**RE: Burger King – 5508 4<sup>th</sup> Street NW**  
**Grading and Drainage Plan**  
**Stamp Date: 10/30/17**  
**Hydrology File: F14D055**

Based upon the information provided in your submittal received 10/30//2017, the Grading Plan **is not** approved for Building and SO-19 Permit. The following comments need to be addressed for approval of the above referenced project:

ENGINEER'S SEAL  10-30-17 Richard Dourte P.E. #10854	Title BURGER KING 4TH ST. AND MONTANO RD 5508 4th Street NW GRADING AND DRAINAGE PLAN  <i>RHD Engineering, LLC</i> 4305 Purple Sage Ave. NW ALBUQUERQUE, NM 87120 (505) 288-1621	DRAWN BY DATE OCT. 2017  SHEET # 1 of 2  JOB #
---	--	--

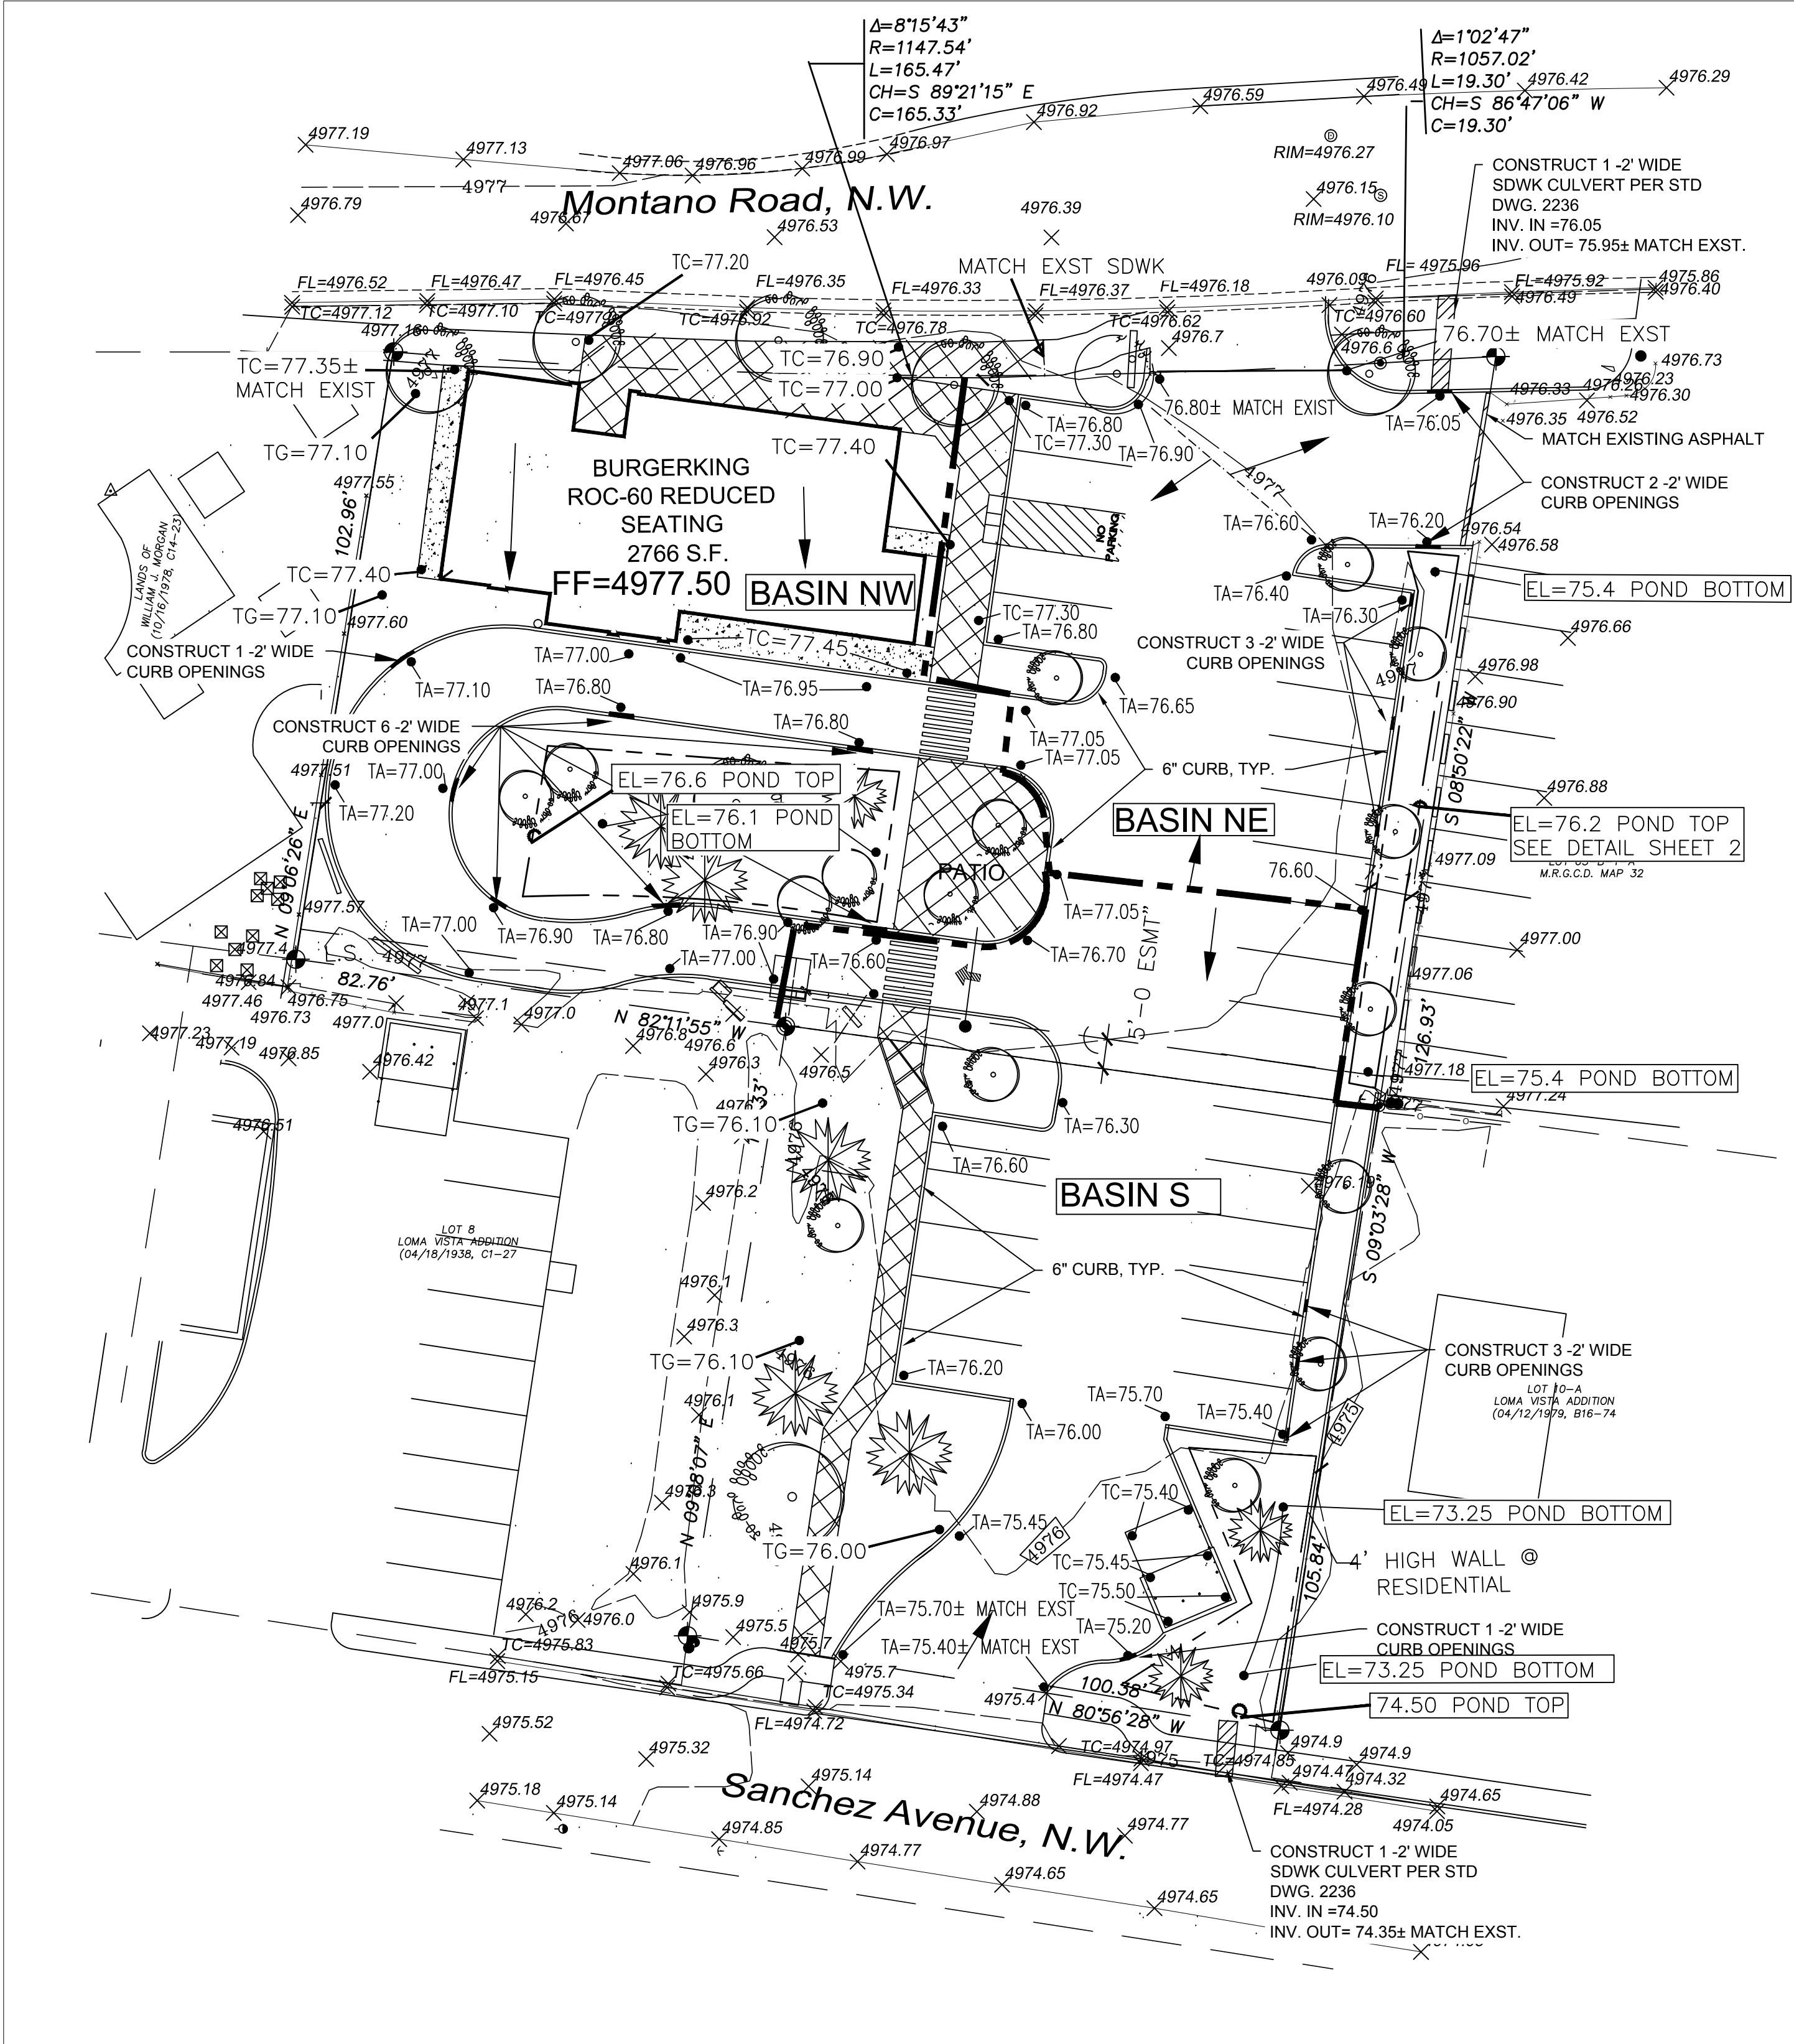
1. Please darken the property line or make the proposed basin boundary go around the property line. It is hard to tell what is within the site.

2. Please provide the weir calculations for the curb cuts and sidewalk culverts.

3. The sidewalk culverts will need a SO-19 Permit. Please mark the DTIS in your re-submittal and add the standard SO-19 notes (See below).
